## ADDENDUM NO. - 2

### RE: ITB# 016-20 – The Banks Bid Package #6 – Lot 23 Park, Lot 23/27 Garage Signage & Security

Addendum to the Construction Documents

**6 SECTION**  
A112 3/8"=1'-0"

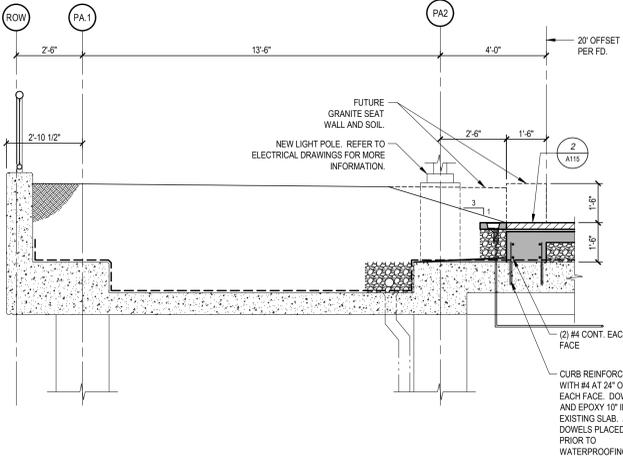
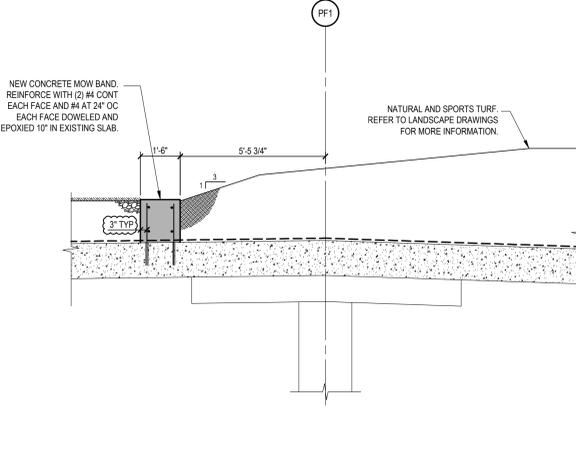
**#5 Question:** Is the 5" concrete slab on the North side of the turf area shown on details 3, 6, 8, 11/A112 to be included in TC-09 or TC-10?

**Answer:** All concrete located below a substrate such as Granite or required to install Park related scope to be in TC-09. Topping slabs that are exposed/to be a walkable surface to be included in TC-10.

**18 SECTION** REFER TO DETAIL 1/A112 FOR TYPICAL NOTES  
A113 3/8"=1'-0"

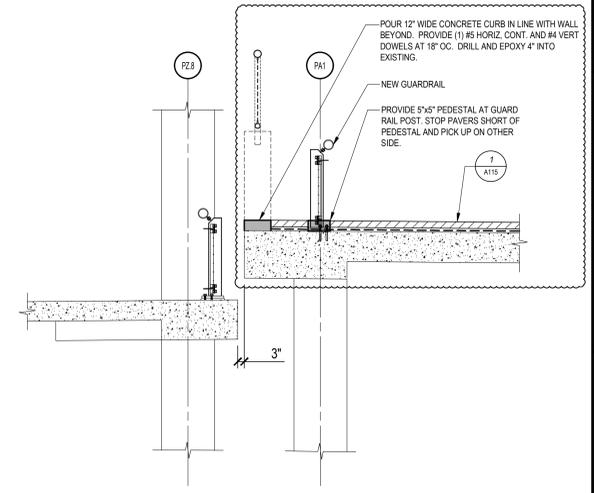
**#4 Question:** What is the spacing of the dowels that are in the concrete for the slot drains similar to detail 13/A113 and 18/A113? Are these spaced at 24" OC similar to 1/A112.

- Curb reinforcing on Detail 18 changed
- Additional information at railing condition on Detail 20 provided
- Added future seat wall conditions

**Answer:** Typically the dowel spacing at the slot drains will be 24" oc. The only exception to this will be the slot drain in the deep tree pits (Detail 18/A113). At this location, there will be #4x2'-6" dowels each end of the curb. Refer to the updated detail in Addendum #2.

1  
A116  
TOP OF EXISTING DONOR WALL AND ADJACENT EXISTING STRUCTURE  
ELEVATION  
3/8" = 1'-0"

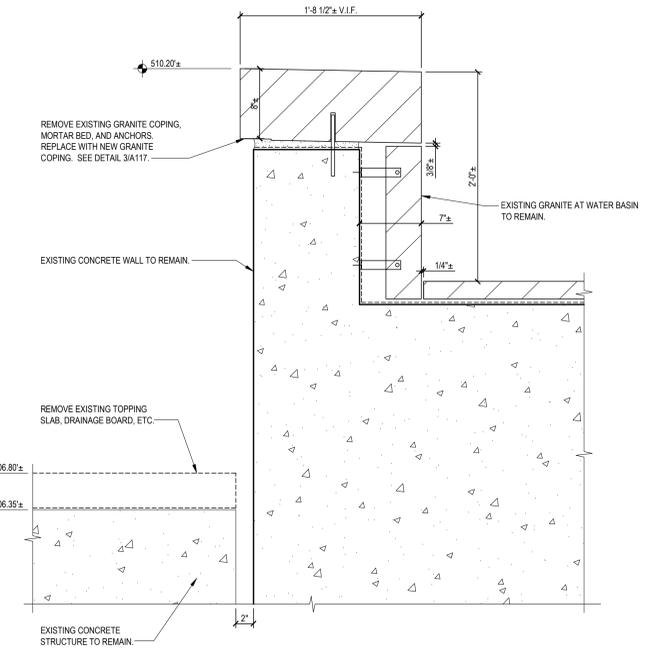
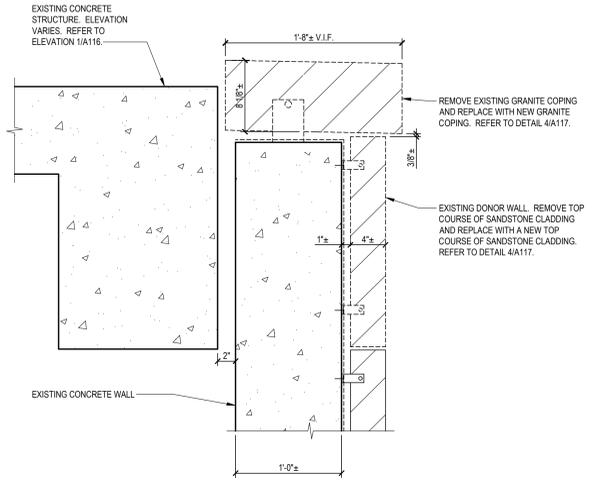
- Update elevation marks on Elevation 1/A116.
- Revise Details 2 & 3/A116.

**7**  
UPPER RACE STREET STAIR WALL  
**DETAIL**  
A293 1 1/2" = 1'-0"

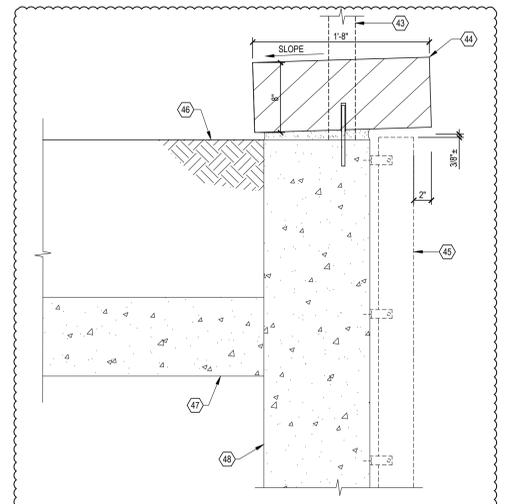
- Added Detail 7 (moved from sheet A115) with updated wall coping and rail information.
